Tasman Resource Management Plan PC76: Wakefield Growth Plan Change

**Report prepared to fulfil the requirements of Section 42A of the
Resource Management Act 1991**

May 2024

Figure 1: Indicative Items Update Area Map 76/1: Submission Point 76.0-2 (Red arrows identify cycle trail); Submission Point 76.0-4 (Orange Circle Oak Tree).

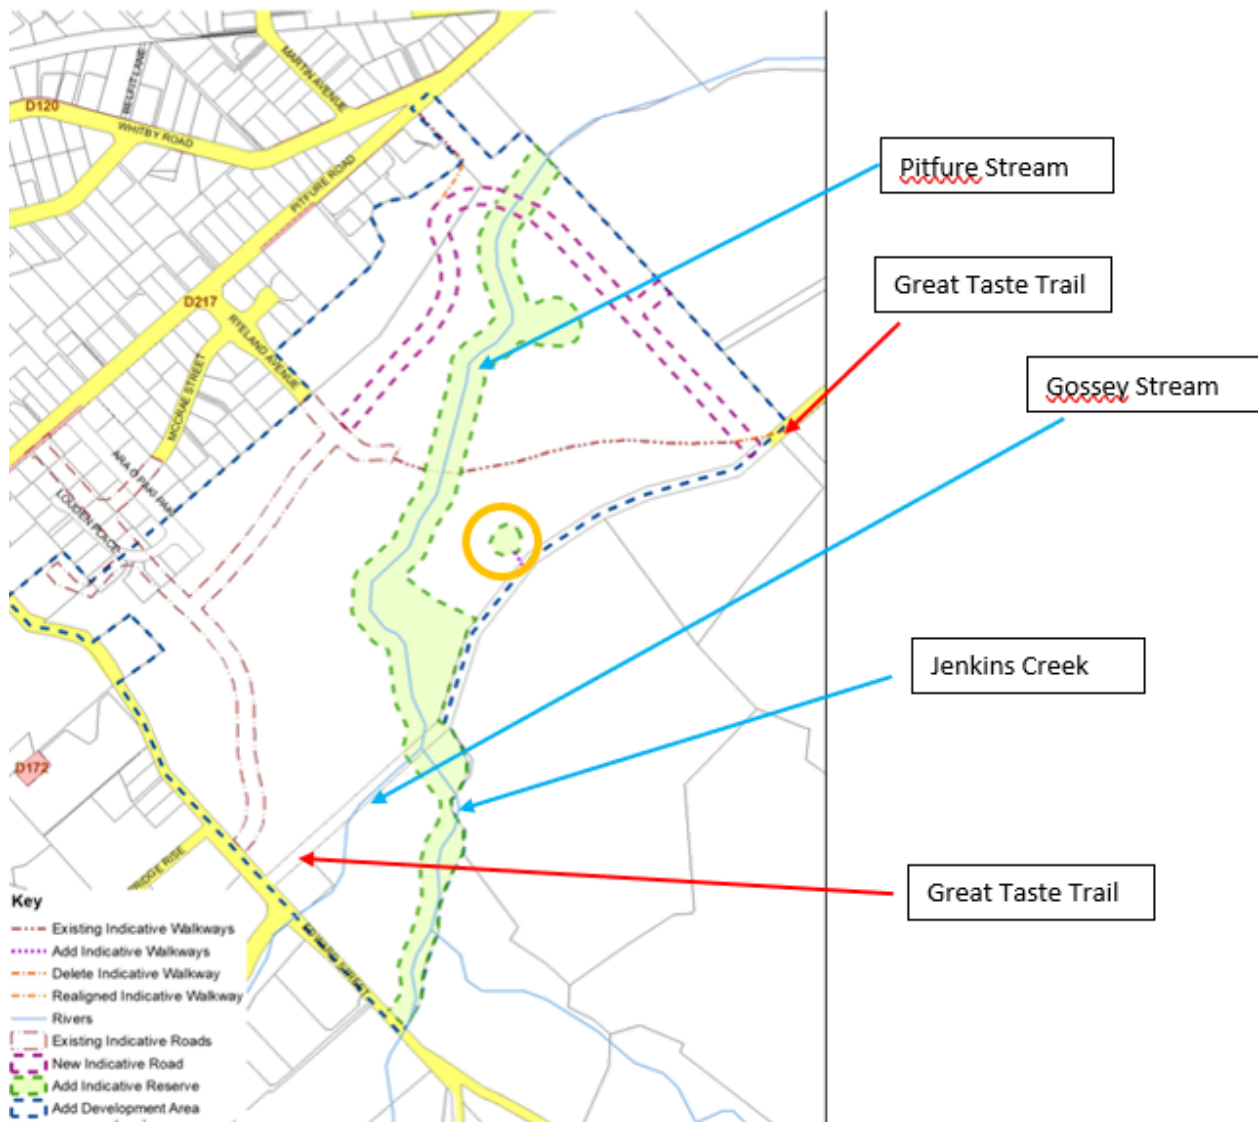
Submission Point 76.0-2 (Jean Gorman) seeks an amendment to the proposed indicative items (Area Map 76/1) to include additional amenity/reserve areas adjoining the Tasman Great Taste Trail where it connects to Edward Street. Figure 1 identifies the Tasman Great Taste Trail referred to in Submission Point 76.0-2.

Gossey Stream will be subject to esplanade provisions because it is greater than 3 metres at its annual fullest flow. The Council's Reserves Team support an amendment of Area Map 76/1 to include an indicative reserve of 20m from the top of each bank of Gossey Stream (where the stream is located within the Wakefield Development Area) - Refer to Appendix 4 for amendments to Area Map 76/1 and Appendix 6 for

Gossey Stream partially adjoins the Tasman Great Taste Trail and the creation of an esplanade reserve along it will create additional public recreational areas and a setback from the majority of the Tasman Great Taste Cycle Trail where it adjoins Gossey Stream, which will (partially) meet the relief sought by Submission Point 76.0-2.

Figure 6: 2024 Flood Modelling (1% AEP Event) with the recommended indicative reserve overlaid (Extract from Appendix 5)

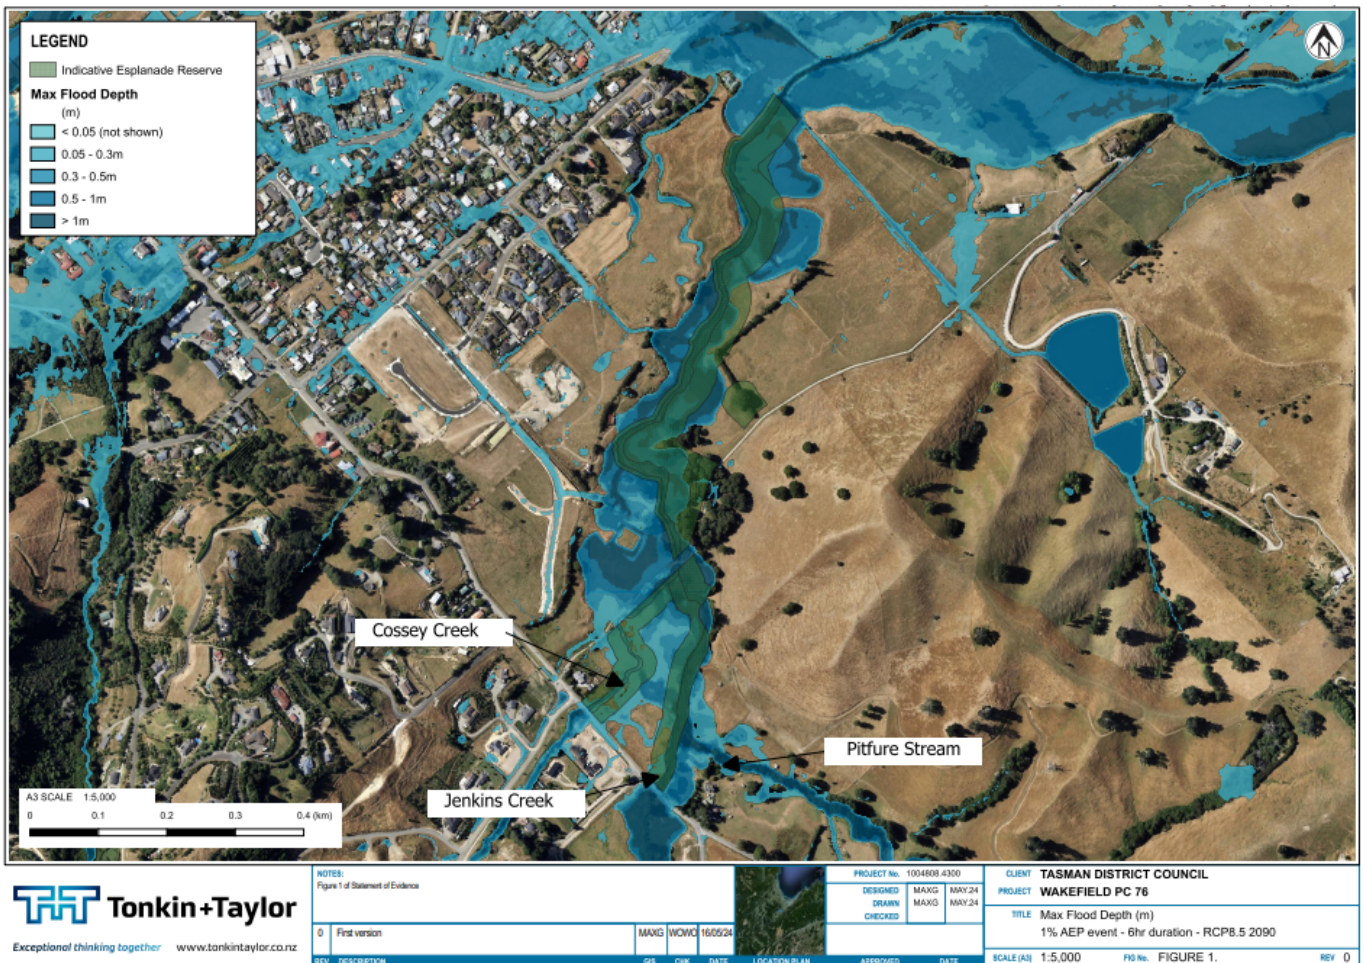
Submission Point 76.0-5 (Jean Gorman) seeks development to be limited within the area identified in Figure 5 due to flooding from Jenkins Creek, Pitfure and Gossey Streams during high rainfall events. The submitter (3653) seeks that development within this area be restricted to the road frontage with Edward Street.

The updated flood modelling indicates that the area between Edward Street, Jenkins Creek and Gossey Creek could get inundated in a future 1% AEP flood event with flood depths varying between 0.05 m and 1 m as shown in Figure 6.

A 20 metre esplanade reserve is recommended either side of Gossey Stream and Jenkins Creek where it extends within the development area. This reserve is illustrated in amended Area Map 76/1 (Appendix 4) and Figure 6 below. Within the area between Edward Street, Jenkins Creek and Gossey Stream the esplanade reserve partially accommodates some of the area expected to be inundated in a future 1% AEP flood event.

Figure 7: Proposed PC76 TRMP Indicative Items and location of 66 Pitfure Road (extract from update Area Map 76/1).

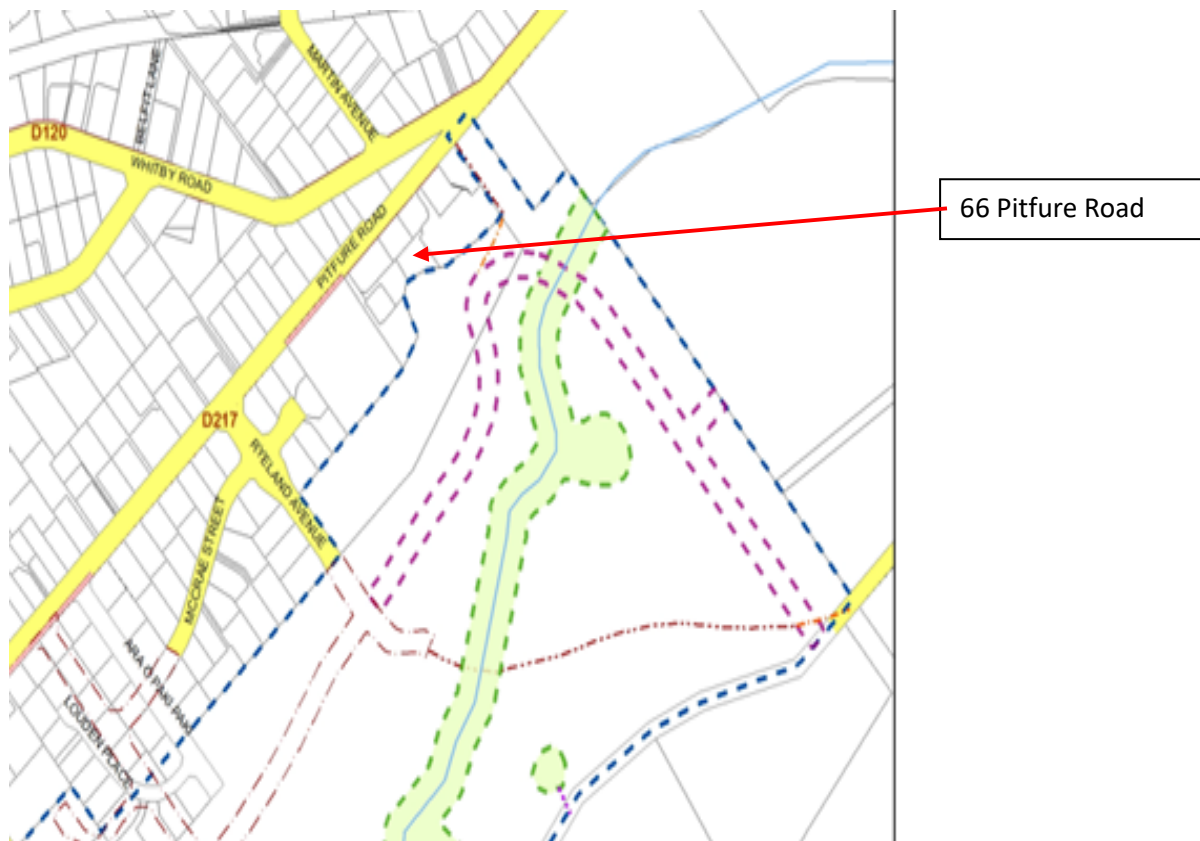
Submission Point 76.0-7: (D 7 K McKay) The submitter (4210) objects to the distance of the indicative road from the boundary to their property at 66 Pitfure Road on the basis of a loss of privacy and traffic noise. In addition, the submission point identifies a possible stream that runs behind their property and questions whether this will be infilled as part of the development works.

Submission Point 76.0-7 seeks amendments to the indicative roading network which would adjust the indicative road so that it is located further away from the submitter's property and other existing residential properties on Pitfure Road. As discussed above, the location of the indicative road is 'indicative' only and will be finalised at the subdivision stage following a TRMP assessment which will consider amenity values. Amendments to Area Map 76/1 are proposed to align with the landowners masterplan and will result in the indicative road network moving closer to Pitfure Stream and further away from the submitters property – refer Appendix 4. This change is considered to address the submitters concerns.

Figure 9: Walkway connection relevant to submission point highlighted (red) (extract from update Area Map 76/1).

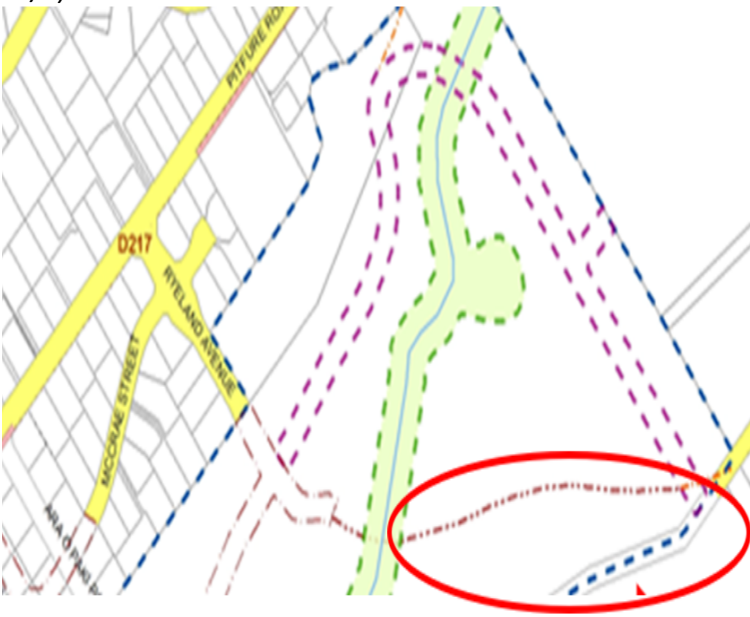
The submitter seeks an amendment to the indicative walkways identified on Area Map 76/1 (Figure 9) to align walkways with the landowners masterplan (Figure 10) which includes a walkway crossing the reserve (and Pitfure Stream) from Ryeland Avenue and extending along the eastern side of the indicative reserve.

The intention of the indicative walkway is to provide an active transport connection from the western side of the plan change area to Higgins Road and the Tasman Great Taste Trail. Amending the walkway to align with the landowner’s masterplan which includes a walkway within the indicative reserve adjoining Pitfure Stream and also a connection to the proposed reserve around the mature oak tree is supported by the Council’s Reserves Team (Appendix 6) and it is therefore recommended that this submission point is accepted and Area Map 76/1 amended to reflect this change.

Figure 12: Area Map 76/1 amendments proposed by Wakefield Village Development Ltd.

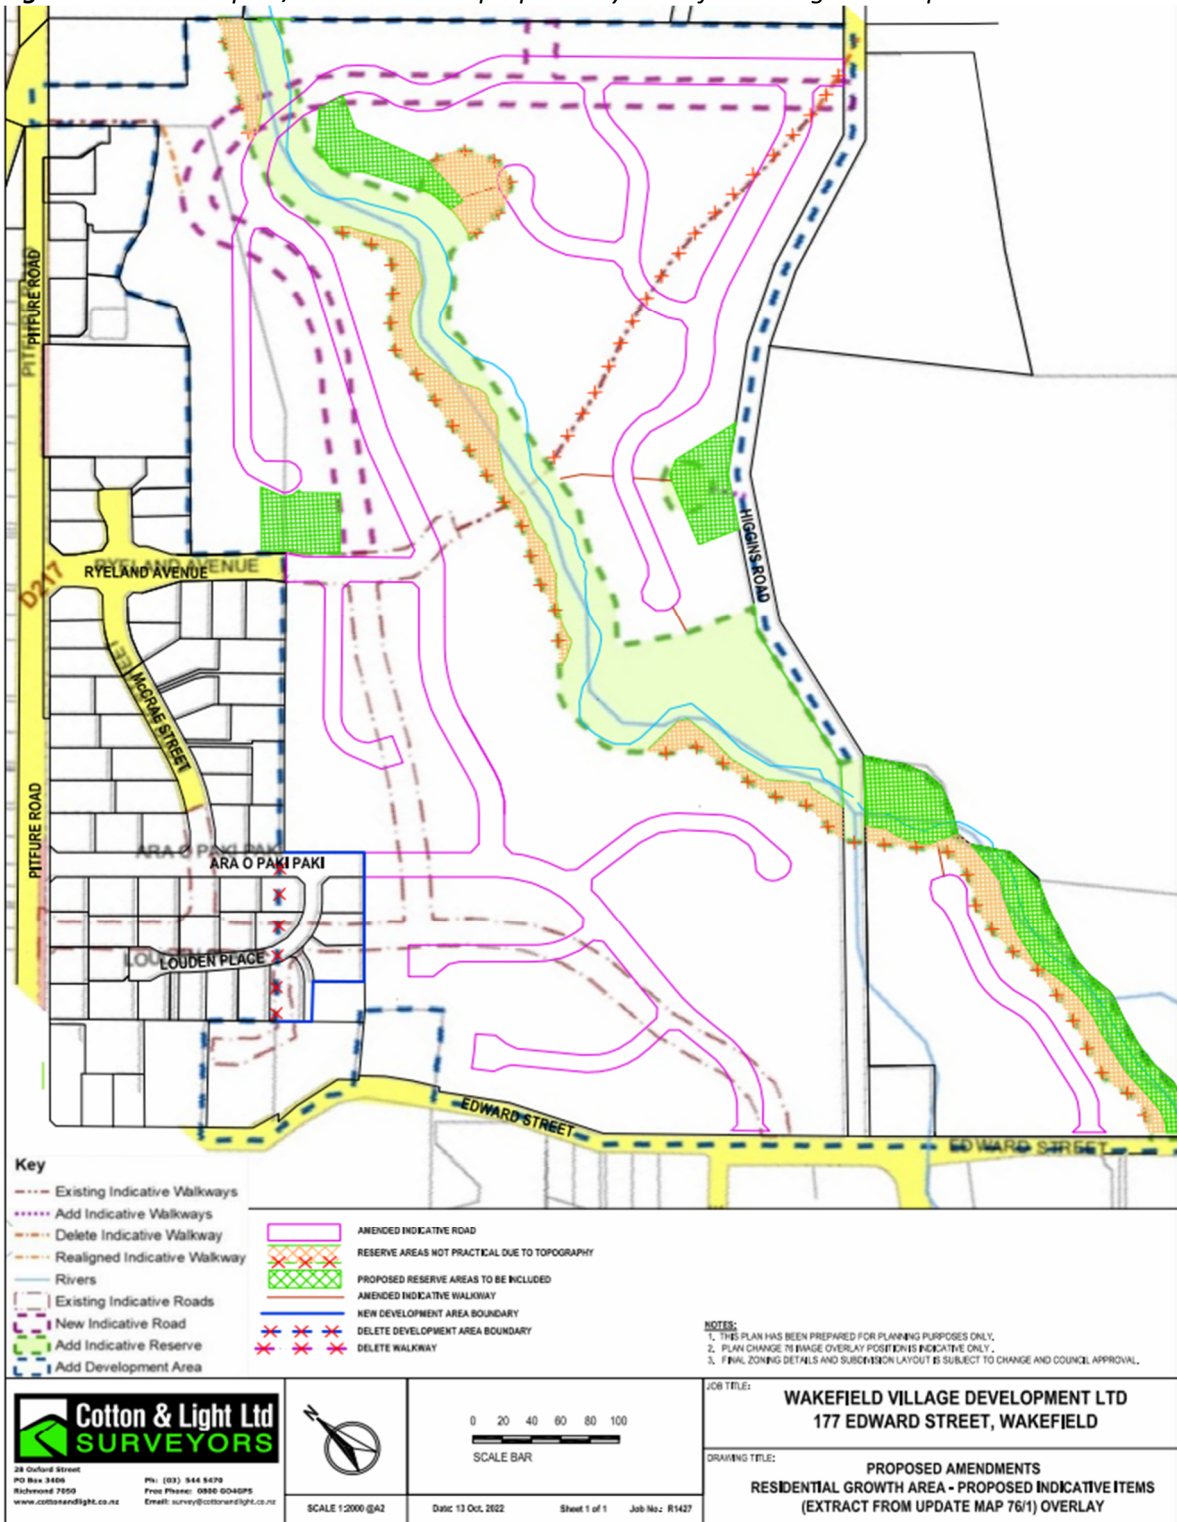
Wakefield Village Development Ltd have requested the removal of areas of the indicative reserve along the Pitfure Stream and an adjustment to the indicative reserves shown on Area Map 76/1 to align with their concept masterplan as identified in Figure 12. The purpose of the indicative reserve along Pitfure Stream is to provide access for public amenity, recreation and stream maintenance and to partially accommodate flood flows (noting that the landowner may need to provide additional land for accommodating flood flows).

- A reduction in the indicative reserve notation (Area Map 76/1) on the true left bank of the Jenkins Creek and Pitfure Streams for its (almost) entire length as depicted in Figure 12.

The Council's Contract Reserve Planner has recommended that the indicative reserve notation on the true left bank of Jenkins Creek and Pitfure Stream from the Edward Road boundary to Higgins Road Reserve is retained to 20 metres from the top of each bank, where it is within the Wakefield Development Area. Refer to Appendix 6 – Supporting Evidence, Reserves. The waterways are greater than 3 metres at their annual fullest flow and therefore recognition through including an indicative reserve along their length is appropriate and supported through provisions in the TRMP.

A reduction in the indicative reserve notation on the true left bank of the Pitfure Stream from Higgins Road to the northern boundary of the Wakefield Development Area is supported to provide for a 6 metre wide level area of land from the top of the bank as shown in Appendix 4. The reason for this is to enable the efficient use of the residential land while providing a corridor for maintenance vehicle, public access, planting and erosion control.

The Council's Contract Reserve Planner supports an amendment to the shape of Oak Tree Reserve provided the reserve is extended to 10 metres from the drip line of the tree. I note that exact dimensions and placement of any indicative items will be determined within the subdivision consent process. Refer to Appendix 4 for amended Area Map 76/1.

The Council's Contract Reserve Planner supports amending the reserve beside Pitfure Stream at the northern end of the development area to provide a more favourable connection for recreational and environmental uses and recognise the flood risk as shown on Appendix 4 and described in detail in Appendix 6. This amendment includes increasing the 20 metre width by 14 metres to make a total width of 34 metres to reflect the reduction in the reserve to 6 metres on the true left bank.

Figure 12: Zone Map 76/2 amendments proposed by Wakefield Village Development Ltd (dark pink shading).

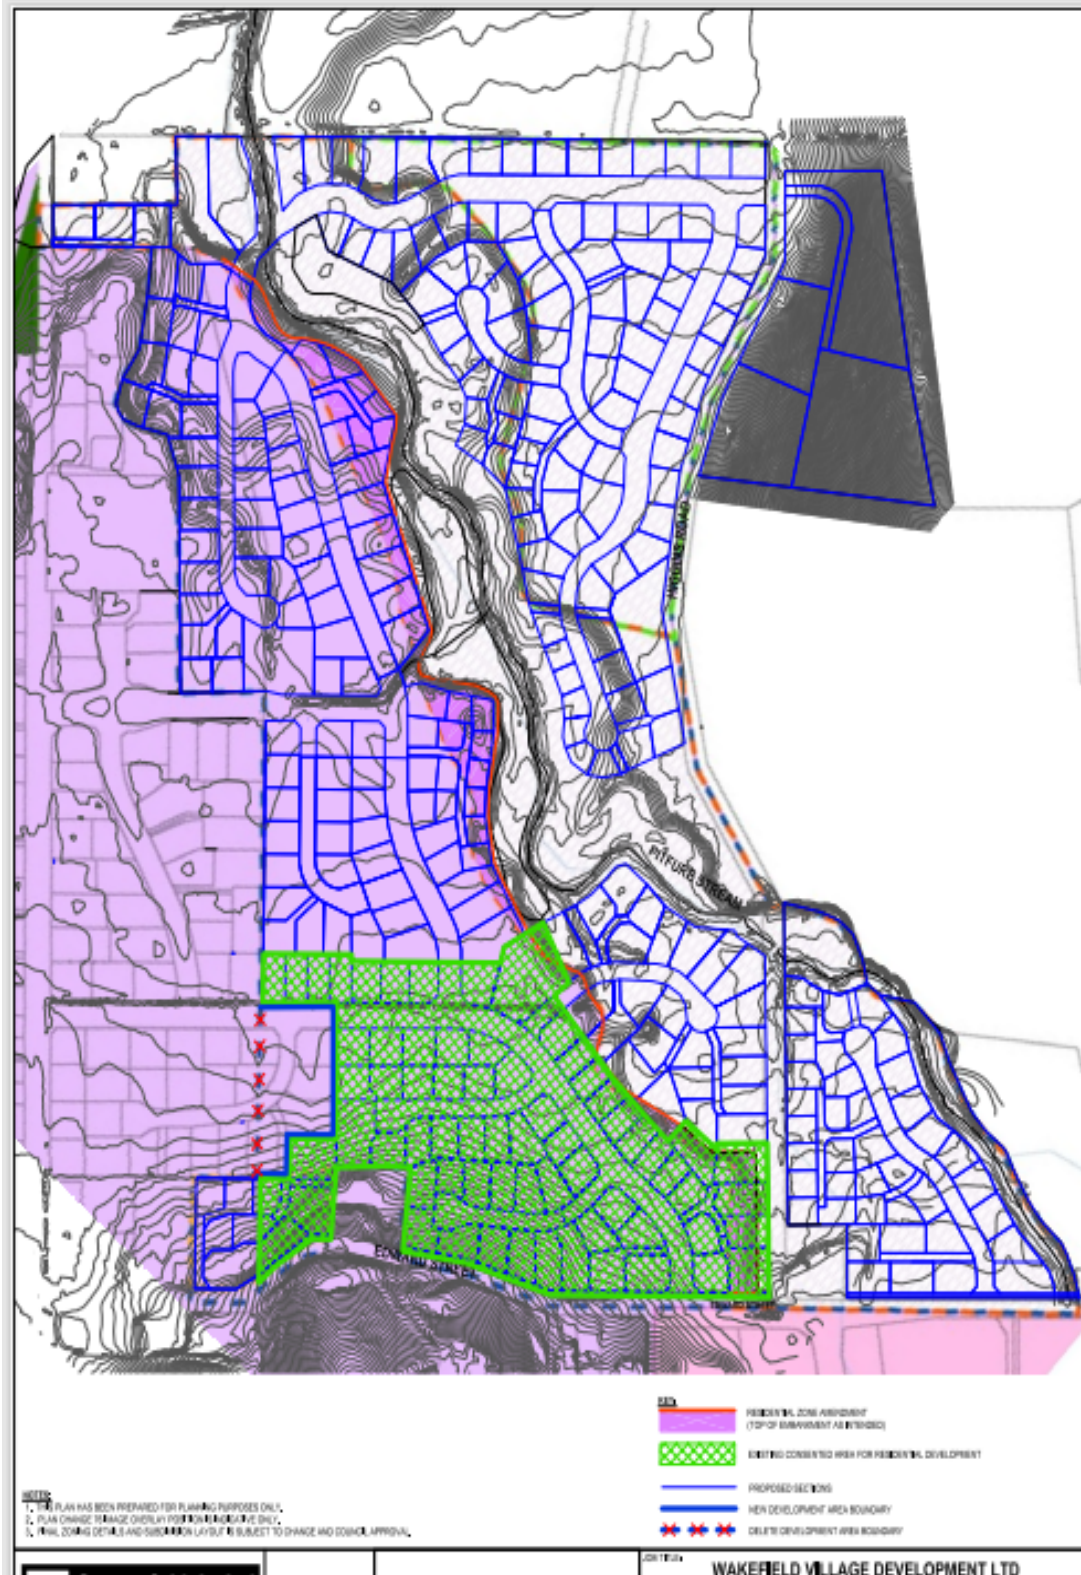
Submission Point 76.0-9 (Wakefield Village Development Ltd) seeks an amendment to the current Residential Zone boundary to follow the existing upper terrace (western side) of the Pitfur Stream as shown on in Figure 12.

Wakefield Village Development Ltd (submission point 76.0-9) has requested that the current Rural 2 zoning within the area identified on the Figure 12 legend as Residential Zone Amendment (dark purple) be rezoned

In the northern part of the development area it is a logical to amend the zoning to align with the topography of the site and prevent the spilt zoning of land particularly where the area of additional land is minimal. It should be noted that there is currently no wastewater servicing capacity for development on the residentially zoned land (or the supported extension to the residential zoning). Wastewater servicing is however included in the Councils 10 Year Plan.

In addition, the Councils Reserves Team have requested a 6m wide esplanade reserve in this area to allow for maintenance, plantings etc (refer Appendix 6). As such it is recommended that this submission point be accepted.
